PLANNING BOARD MEETING AGENDA

TO: Christian Smith, Beals Associates
FROM: Mark Connors, Planning & Community Development Director
RE: **Windsong Place Subdivision Staff Comments**

The applicant, Chinburg Properties, Inc. of Newmarket, NH, is proposing to construct a six-lot subdivision off Bunker Hill Ave. On the Town's behalf, CMA Engineers has reviewed the application for conformance with the Town of Stratham, NH, Site Plan Review Regulations. CMA Engineers has received the following information for review, all prepared by Beals Associates, PLLC of Stratham, NH:

**SUBDIVISION PLAN
FOR
KENNETH F. LANZILLO
IRREVOCABLE TRUST
OF
TAX MAP 6 LOT 167
189 BUNKER HILL AVENUE
STRATHAM, NEW HAMPSHIRE
COUNTY OF ROCKINGHAM**
SCALE: 1"=60' (22x34) 1"=120' (11x17)

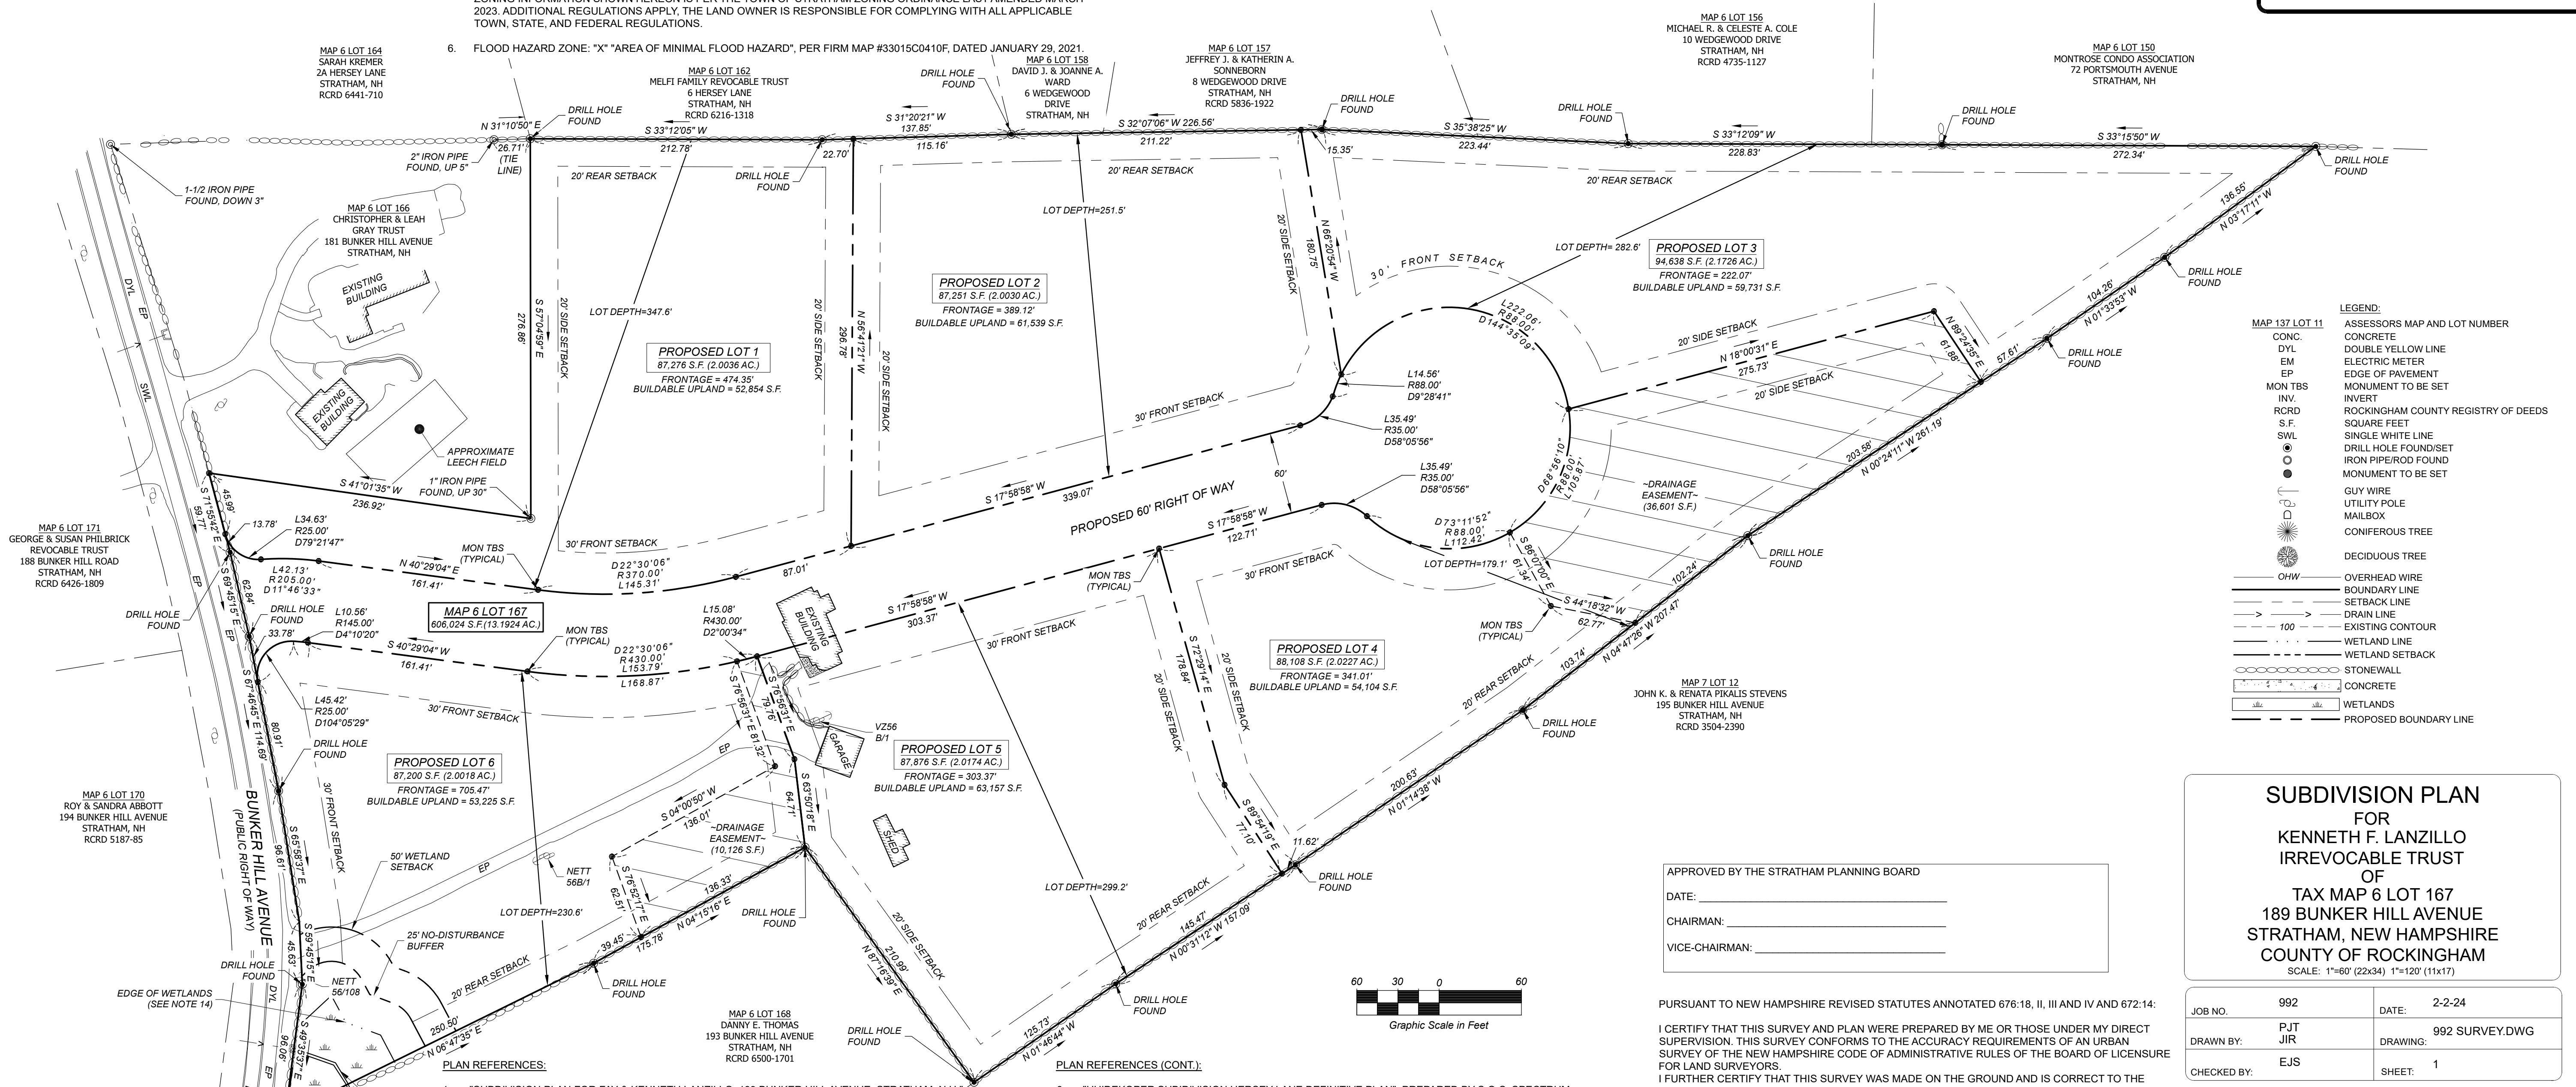
- a) The Subdivision Plan and Existing Conditions Plan erroneously show Bunker Hill "Road" instead of Ave.

- b) There are two Notes 4. On the Subdivision Plan.

Response: Plans have been revised to Avenue.

Response: The additional "4" has been removed.

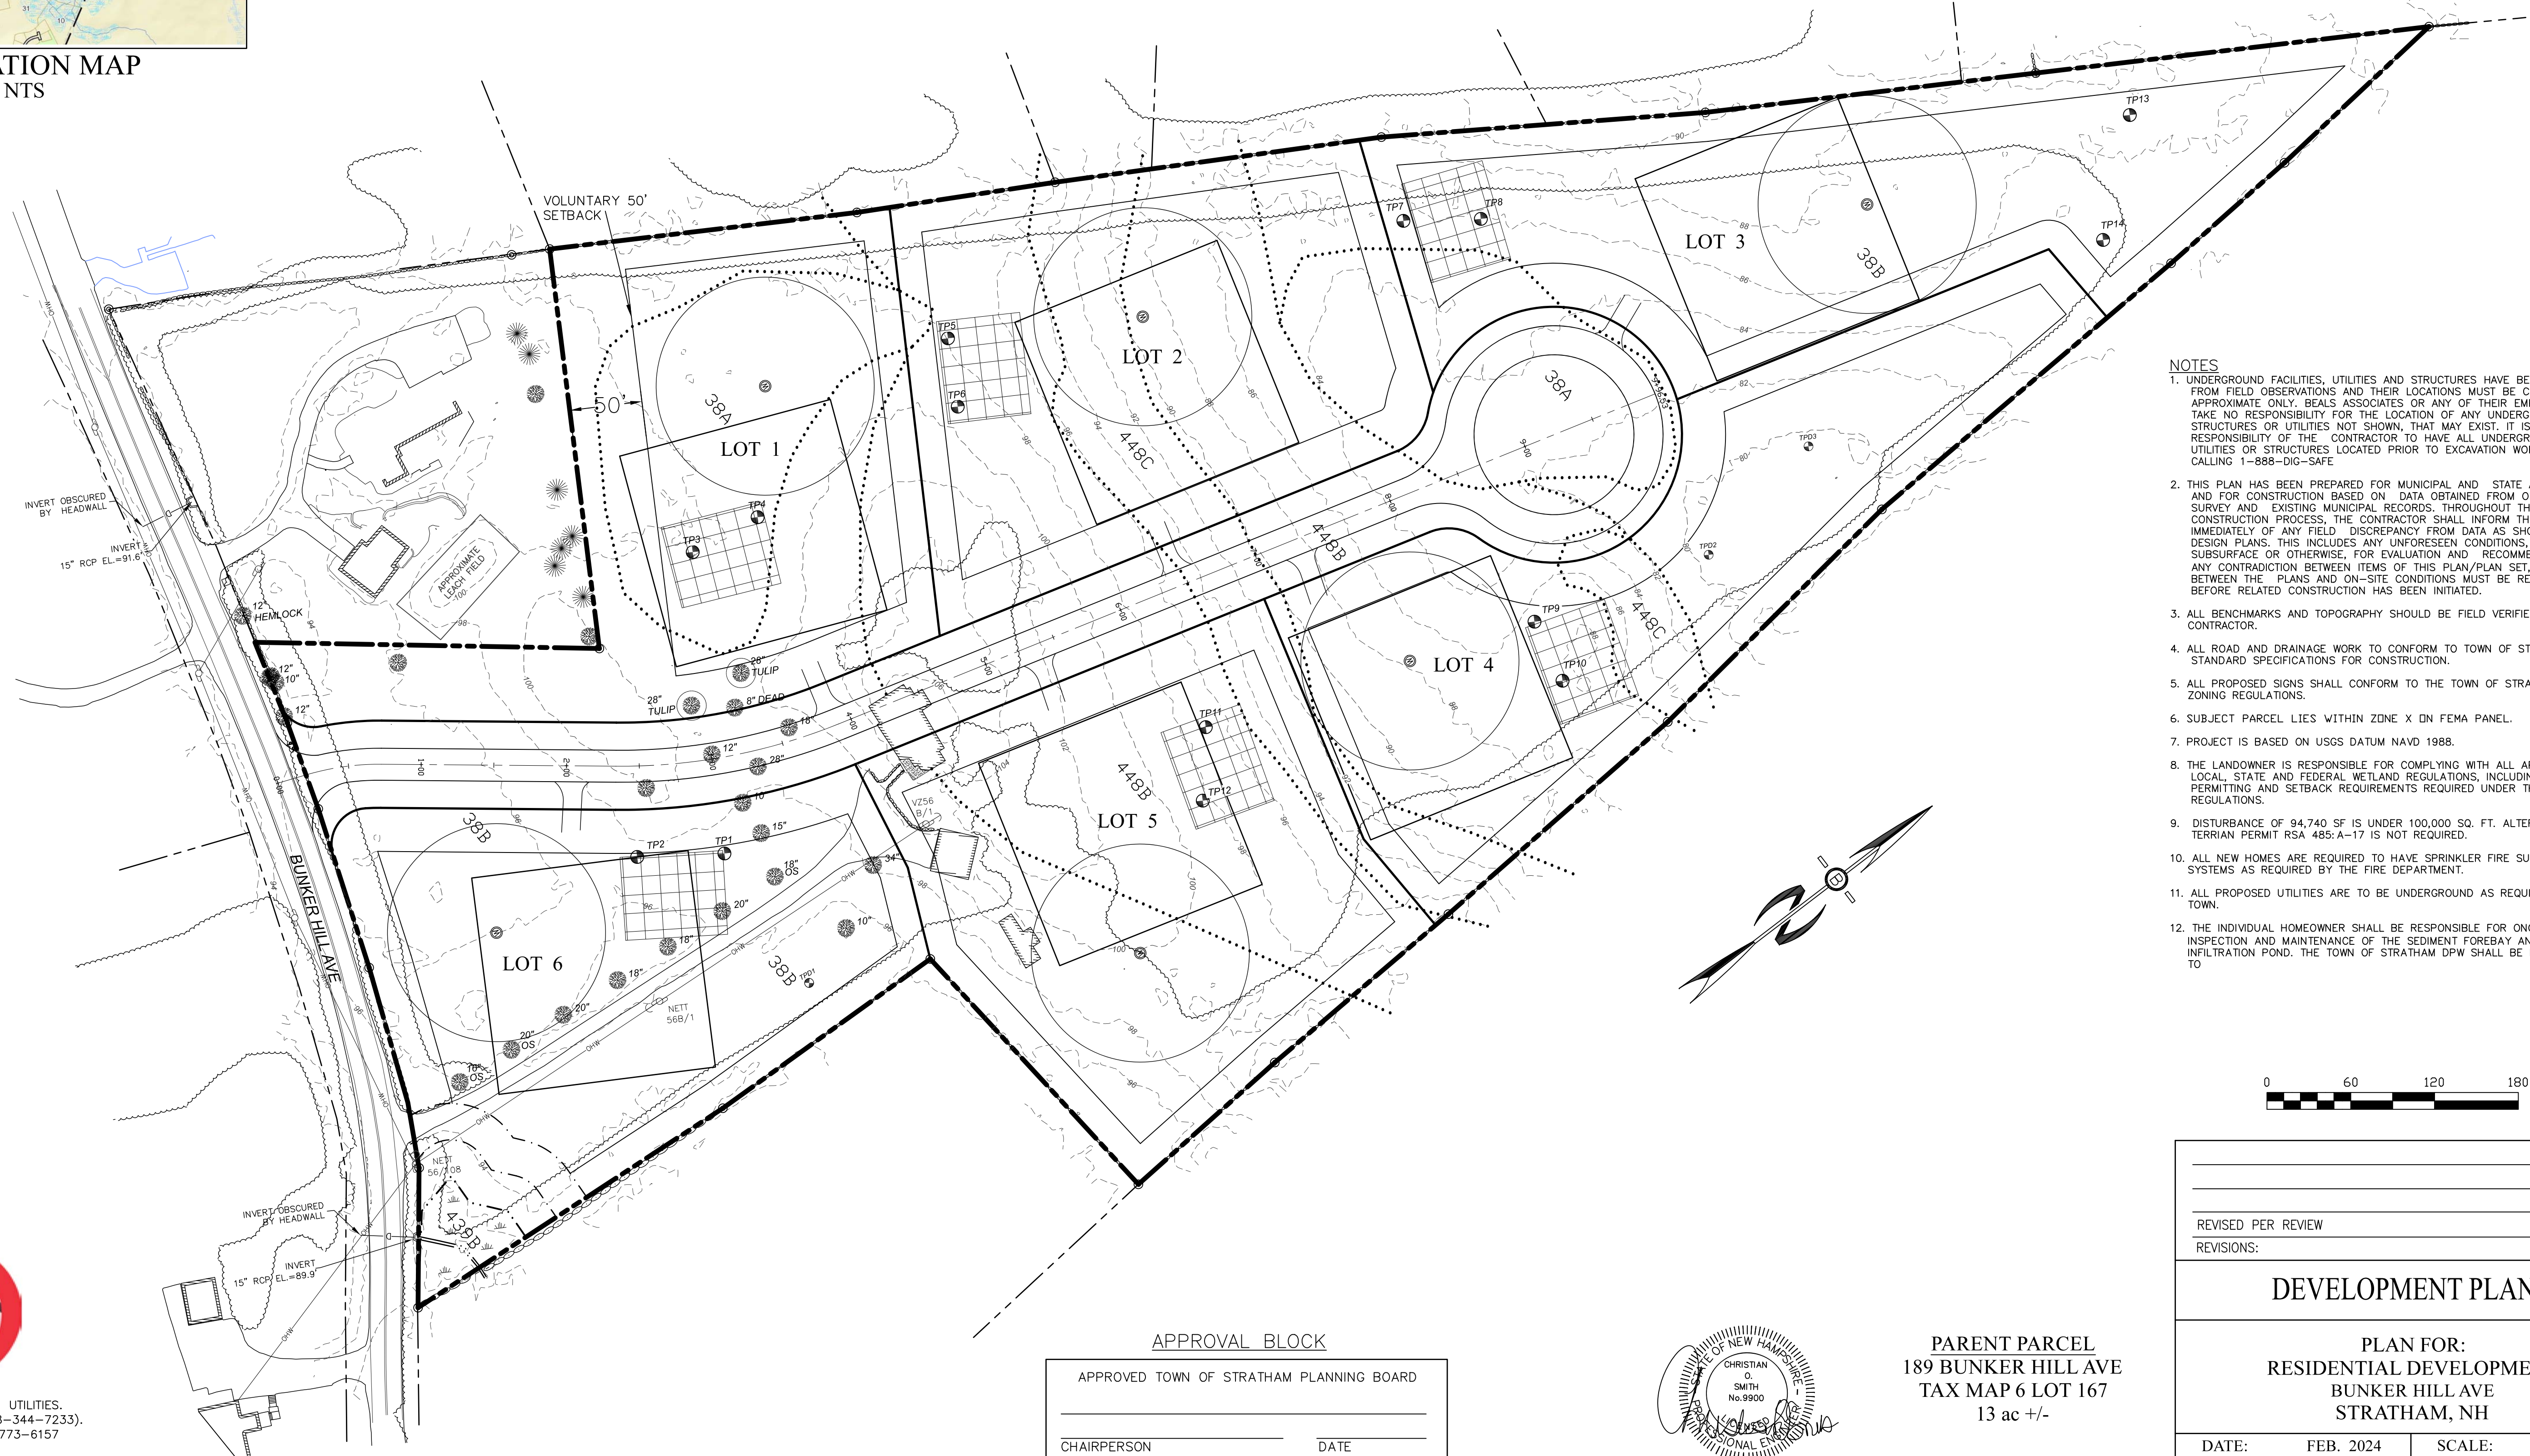
- 13) Note 11 on Sheet 3 should be revised to note the type of sprinkler systems proposed and to note that they would fully serve all living spaces as previously indicated.

- e) Note 11 on Sheet 3 indicates utilities are proposed to be underground but these are not shown on the plan.

Response: When a manufacturer is selected by the applicant, that information will be provided to the Town. Sprinkler systems, if supplied over a water cistern, will fully serve all living spaces.

Response: These will be provided when the utility company provides their response.

INFILTRATION POND DETAIL

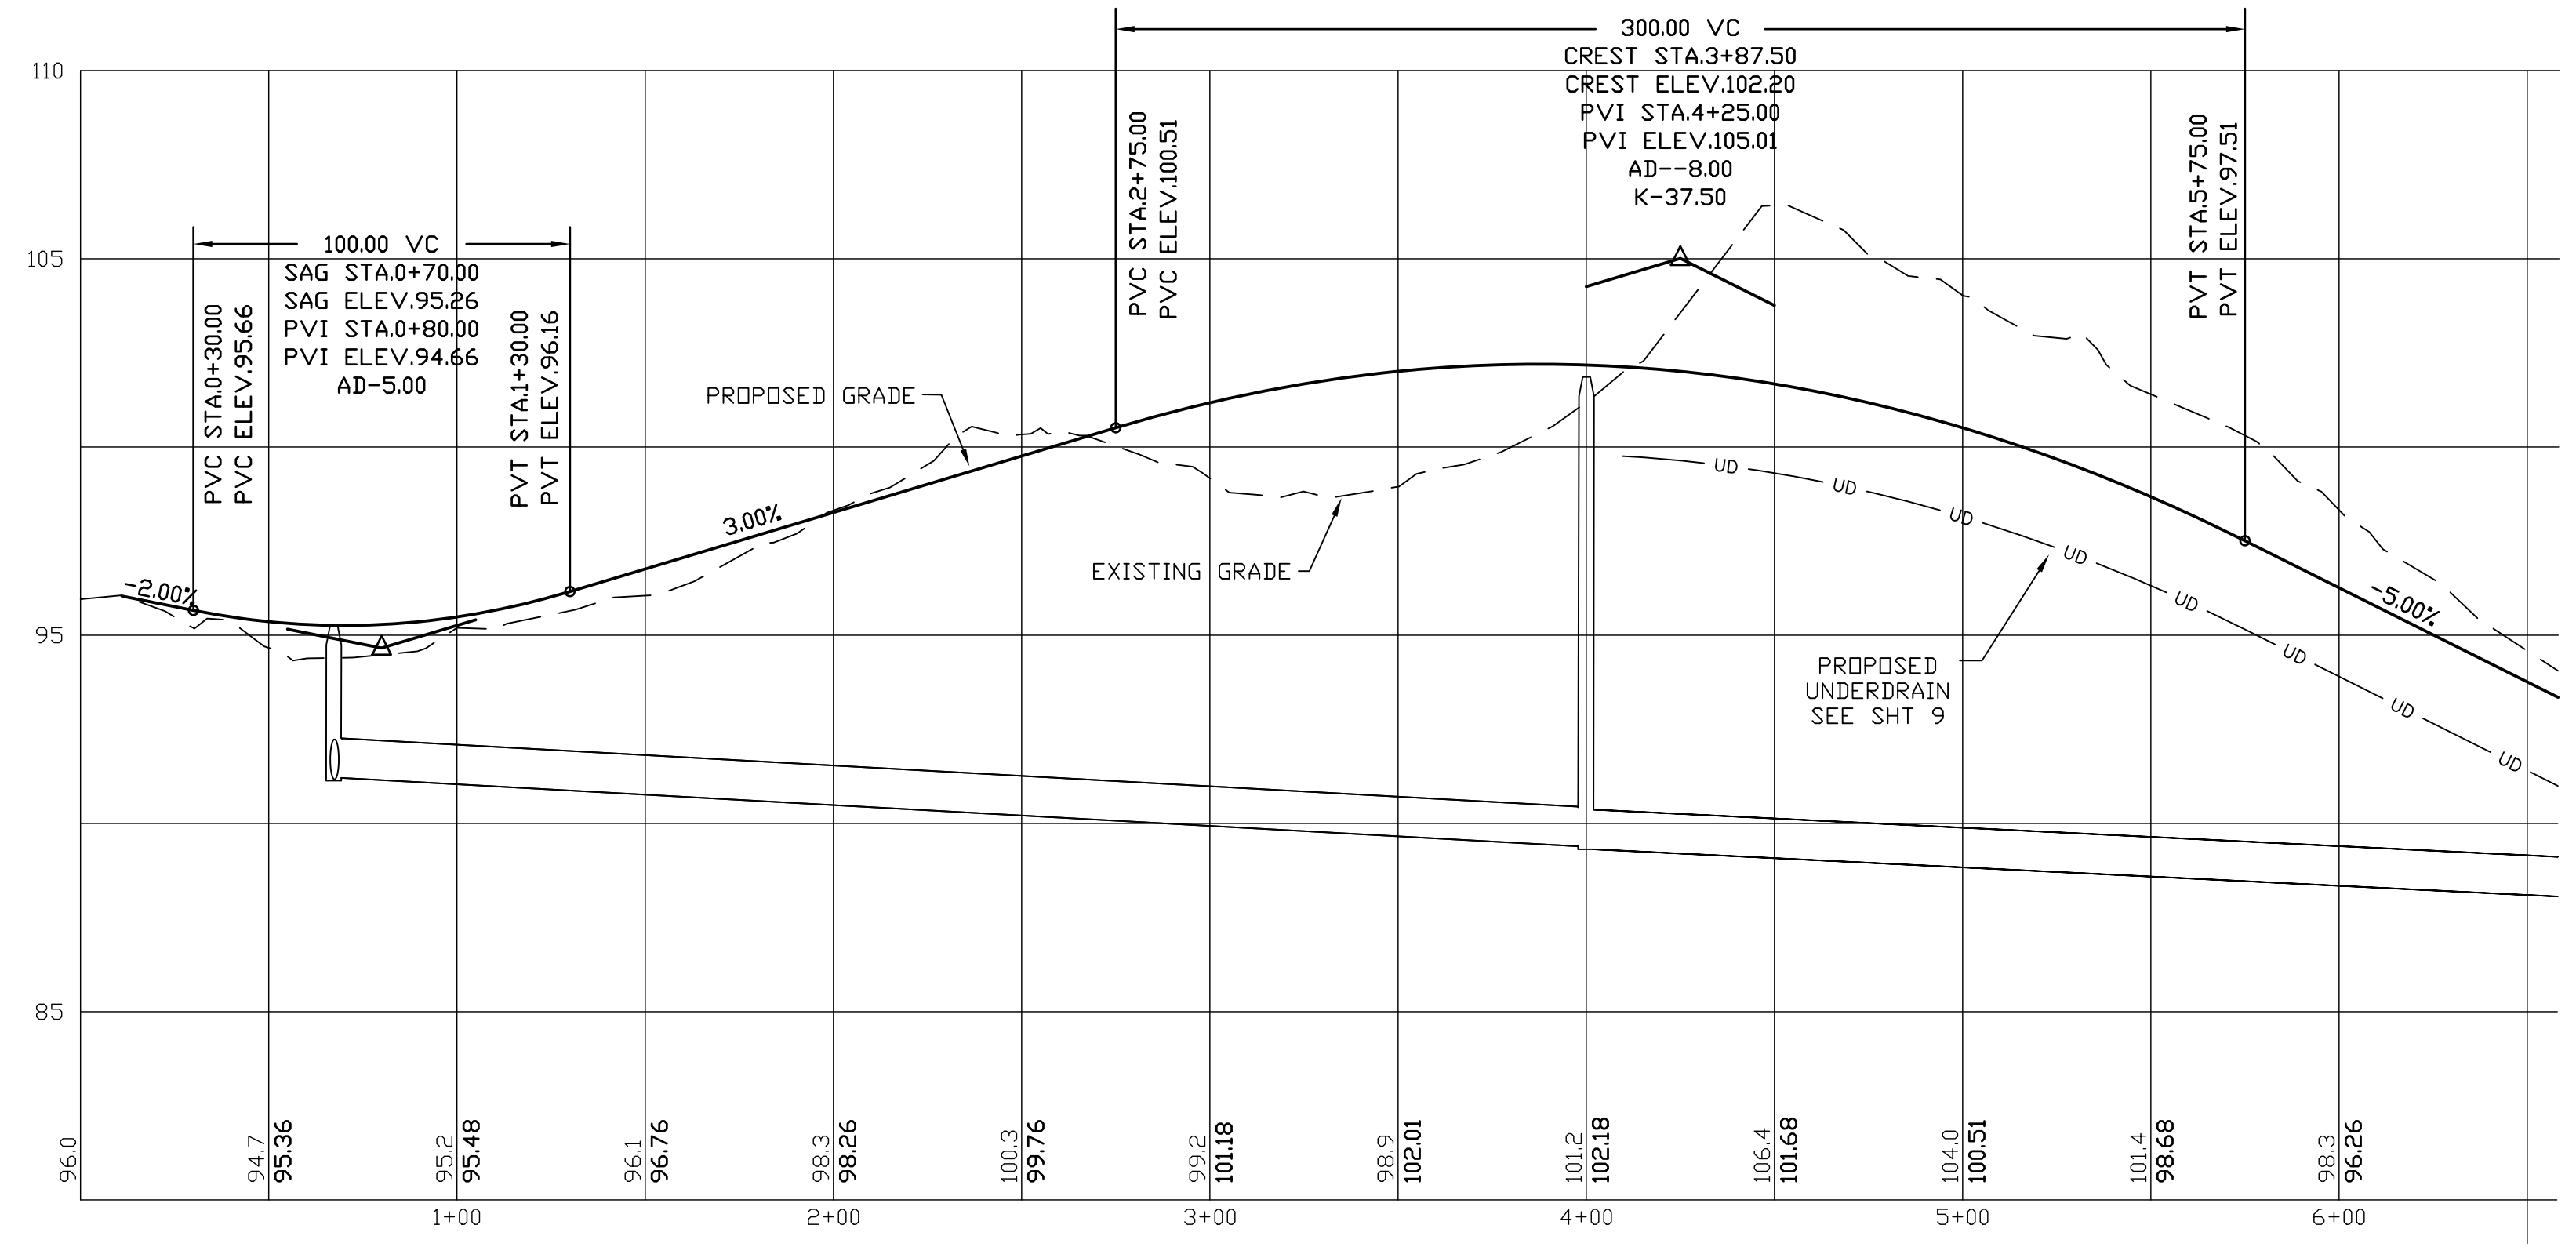
- b) Infiltration pond #2 does not have 3' or greater separation from groundwater. Additionally, the Infiltration Pond Detail on Sheet 5 should show the required 6" of coarse sand or pea gravel. Verify that the pond can hold the 50-year, 24-hour storm without overtopping.

Response: Per NHDES regulations, separation can be reduced to 1 foot if treated prior to entering the practice.

STREET SIGN DETAIL

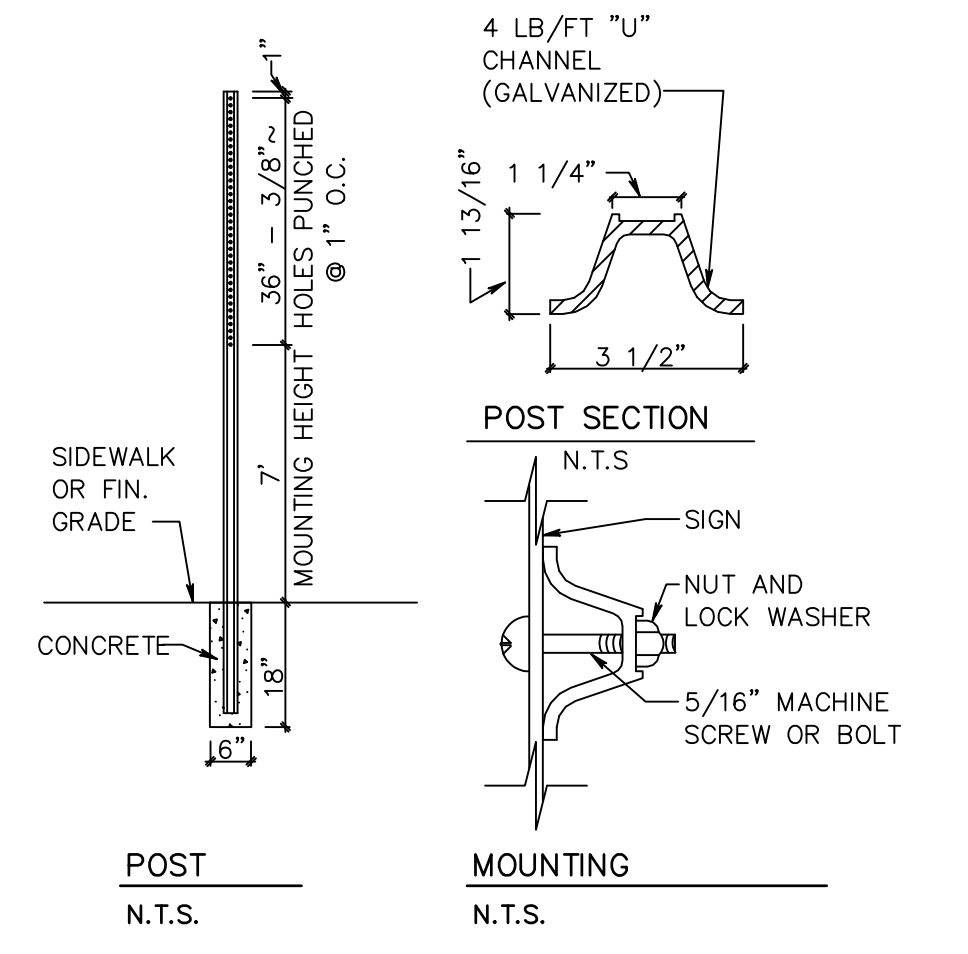
- i) A stop sign and road sign are indicated on the plans but no details are provided. The plans should also show a stop bar.

Response: A sign detail has been added and the addition of a stop bar will be per NHDOT.
